Access Compliance Report

Public Rights-of-Way

(Curb Ramps)

Intersection ID: 27349	Main Street: DOVEHUNT_PL	Cross Street: MCALPINE_VALLEY_CT	Location: NE
ADA ID: 275FE9EB4B73	Ramp Type: PerpDiag	Initial Pass/Fail: Fail	Overall Compliance: No
Severity Score: 67.5			
Codes/Mitigation Info/Possible Solution		Field Measurements/Component Compliance

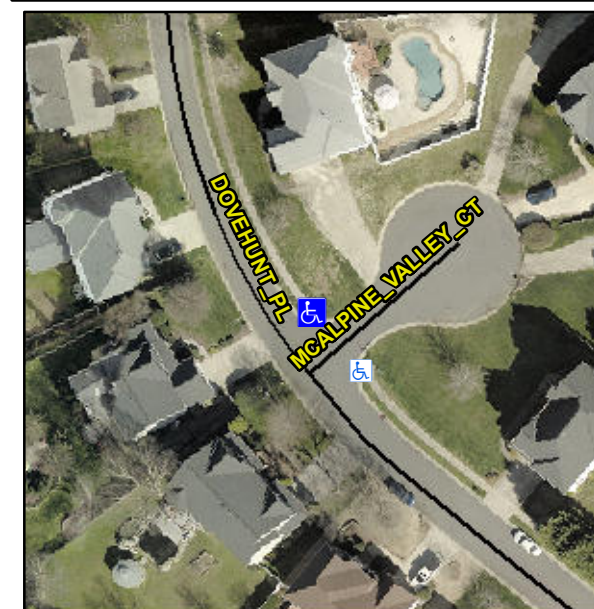
Not Found, R304.5.1, R304.2.2, R304.5.3

Compliance	Description	Data	Compliance	Description	Data
N/A	Ramp Length (in)	89.0	No	Ramp Slope (%)	13.7
No	Ramp Width (in)	33.0	No	Ramp XSlope (%)	10.4
N/A	Flare Type LT	N/A	N/A	Flare Type RT	N/A
N/A	Flare Slope LT (%)	N/A	N/A	Flare Slope RT (%)	N/A
N/A	Flare Traversable LT?	N/A	N/A	Flare Traversable RT?	N/A
N/A	Landing Length (in)	N/A	N/A	DWS Provided?	N/A
N/A	Landing Width (in)	N/A	N/A	DWS Contrast?	N/A
N/A	Landing Slope (%)	N/A	N/A	DWS Length (in)	N/A
N/A	Landing X Slope (%)	N/A	N/A	DWS Full Width?	N/A
N/A	Landing Curb? (Y/N)	N/A	N/A	DWS Offset (in)	N/A
N/A	Shared Landing?	N/A			
N/A	Gutter Ponding?	N/A	N/A	Gutter Slope (%)	N/A
N/A	Gutter Lip Ht (in)	N/A	N/A	Gutter X Slope (%)	N/A
N/A	Painted X Walk1?	No	N/A	Painted X Walk2?	No
	X Walk 1 Direction	To SW		X Walk 2 Direction	To SE
N/A	X Walk 1 Width (in)	N/A	N/A	X Walk 2 Width (in)	N/A
	X Walk 1 Slope (%)	7.7		X Walk 2 Slope (%)	4.8
	X Walk 1 X Slope (%)	7.1		X Walk 2 X Slope (%)	8.5

Remove & Replace Curb Ramp With Two New Directional Ramps or Equivalent.
